HISTORIC DISTRICT COMMISSION ADDITIONAL INFORMATION REQUEST

Application Number: HDC2026-00290

NAME: Ikenna Okereke		COMPANY NAME: N/A	
ADDRESS: 1977 Atkinson St.	CITY: Detroit	STATE: MI	ZIP: 48206
PROJECT ADDRESS: 1977 Atkinson St., Detroit, MI			
HISTORIC DISTRICT: Atkinson Avenue

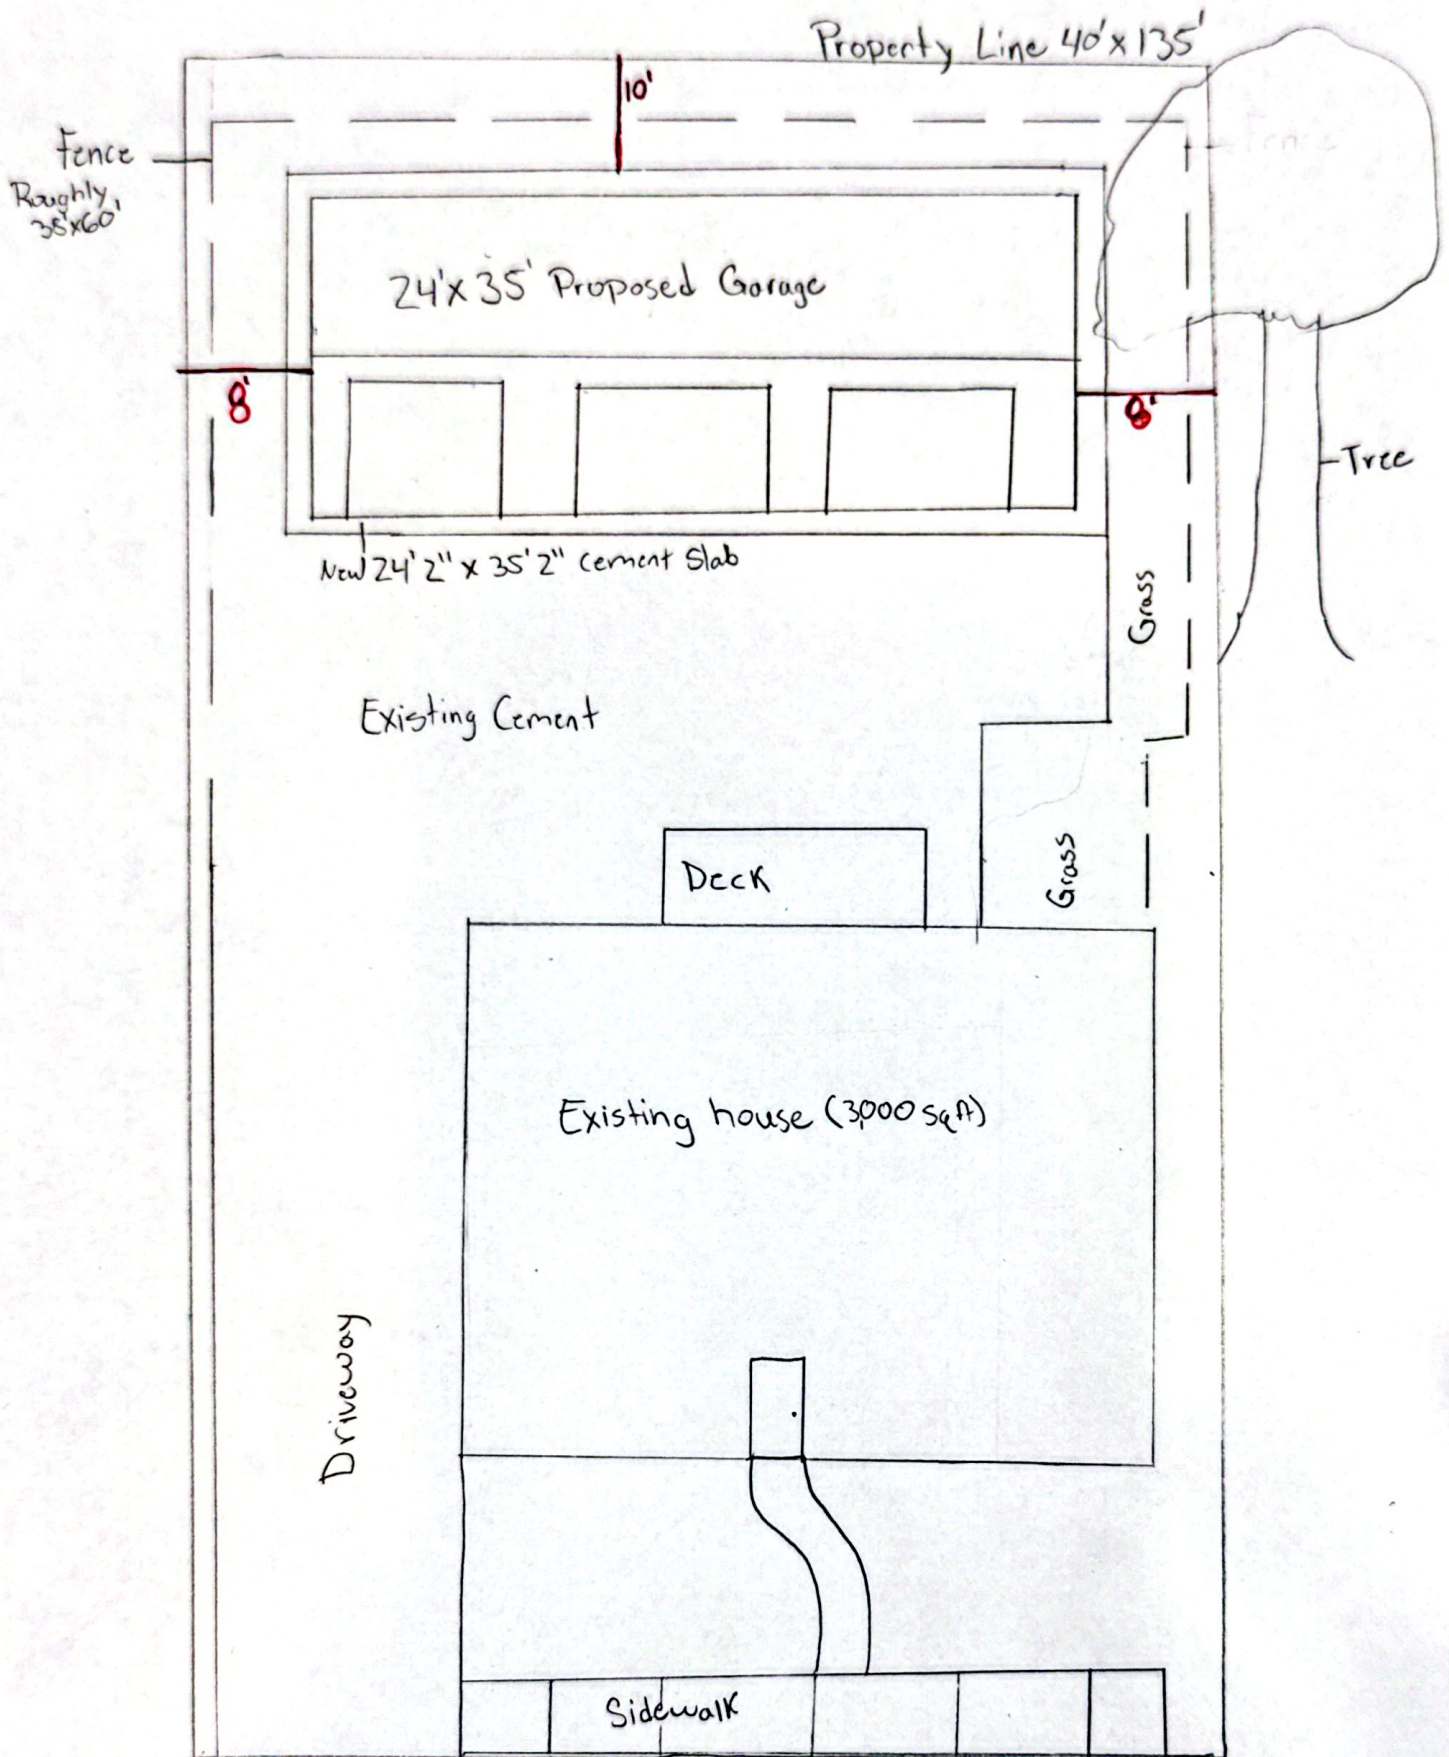
- Product cut sheet for the gable vents. What do they look like? What material are they? Are they brown like the siding? You mentioned black trim--is the trim steel painted black? Please provide a photo or illustration of the gable vent.
- Product cut sheet for the windows. What do they look like? Do they open? If so, how do they open? What material are they? What color? You mentioned black trim--is the trim steel painted black? Please provide a photo or illustration of the proposed windows.
- A marked-up site plan that shows:
 - property lines with dimensions,
 - fence with dimensions,
 - house with any rear features like a deck
 - existing concrete and dimensions (including driveway and the concrete area between the house and the rear lot line),
 - new proposed concrete with dimensions, and
 - the garage footprint with dimensions
 - trees or any other features

Product Type	Gable Vent	Shape	Square
Color	White	Overall Width	14.5 inch
Overall Height	14.5 inch	Overall Depth	1.75 inch
Rough Opening Height	12 inch	Rough Opening Width	12 inch
Ventilation Area	39.6 square inch	Material	Aluminum
Weight	0.63 pound	Shipping Dimensions	14.50 H x 14.50 W x 1.50 D
Shipping Weight	0.6875 lbs	Return Policy	Regular Return (view Return Policy)

- 39.6 sq in. of net free area per unit
- Exhaust vent
- Wall louver
- Aluminum construction
- Helps maintain a balanced ventilation system
- Flush flange
- No screen
- Helps keep the attic cool in the summer and dry in the winter
- Prevents mold
